Access Compliance Report

Public Rights-of-Way

(Curb Ramps)

Intersection ID: 11349	Main Street: N_DAVIDSON_ST	Cross Street: PARKWOOD_AV	Location: W
ADA ID: 242808FE5BD4	Ramp Type: Perp	Initial Pass/Fail: Fail	Overall Compliance: No
			Severity Score: 21.25

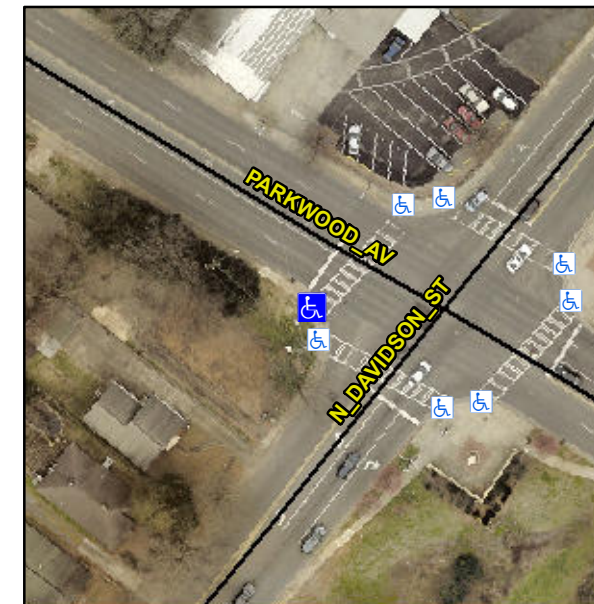
Not Found, R304.5.1, R304.2.2

Compliance	Description	Data	Compliance	Description	Data
N/A	Ramp Length (in)	62.0	No	Ramp Slope (%)	9.2
No	Ramp Width (in)	47.0	Yes	Ramp XSlope (%)	1.4
N/A	Flare Type LT	N/A	N/A	Flare Type RT	N/A
N/A	Flare Slope LT (%)	N/A	N/A	Flare Slope RT (%)	N/A
N/A	Flare Traversable LT?	N/A	N/A	Flare Traversable RT?	N/A
N/A	Landing Length (in)	N/A	N/A	DWS Provided?	N/A
N/A	Landing Width (in)	N/A	N/A	DWS Contrast?	N/A
N/A	Landing Slope (%)	N/A	N/A	DWS Length (in)	N/A
N/A	Landing X Slope (%)	N/A	N/A	DWS Full Width?	N/A
N/A	Landing Curb? (Y/N)	N/A	N/A	DWS Offset (in)	N/A
N/A	Shared Landing?	N/A			
N/A	Gutter Ponding?	N/A	N/A	Gutter Slope (%)	N/A
N/A	Gutter Lip Ht (in)	N/A	N/A	Gutter X Slope (%)	N/A
N/A	Painted X Walk1?	Yes	N/A	Painted X Walk2?	N/A
	X Walk 1 Direction	To NE		X Walk 2 Direction	N/A
N/A	X Walk 1 Width (in)	113.0	N/A	X Walk 2 Width (in)	N/A
	X Walk 1 Slope (%)	2.3		X Walk 2 Slope (%)	N/A
	X Walk 1 X Slope (%)	0.5		X Walk 2 X Slope (%)	N/A

Remove & Replace Entire Ramp.
